Project:	**C9727 - I-405, Brickyard to SR 527 Improvement Project**
Document Name:	**BY-CRE-01827_009727_SUB_17.02_Package 8 Final Fish Passages - Juanita Creek**
Submittal Date:	**1/28/2025**
Due Date:	**2/11/2025** **COB**
Reviewer:	**Jason Pang (JP), City of Kirkland (COK), Gabe Ng (G. Ng), Chris Vondrasek (CV), Sam Michels-Boyce (SMB), Darrell Sofield (DS)**
Document Lead:

Formal Design Review
Form RCSR (Review Comment Summary and Resolution)

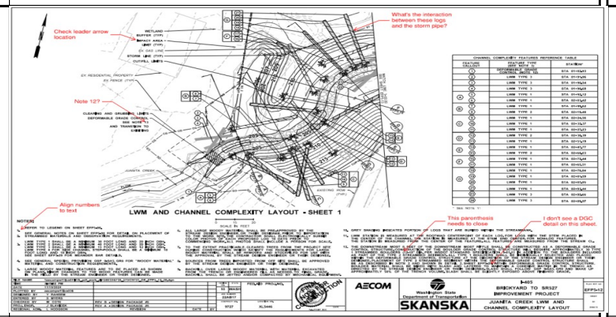
COMMENT (WSDOT, City, Checker)					RESPONSE TO COMMENT (Skanska, Originator of Document)			RESPONSE TO RESPONSE (WSDOT, City, Checker)		Skanska CLOSE
No.	Report or Sheet No.	Comment By	TR/Spec Section	Comment	Disposition Code	Response By	ACTION TAKEN / Remarks	WSDOT Disposition Code	Comments / Action Items	Final Disposition Code
138	FHD PDF pg 125 (App D, EFP5-12)	SMB
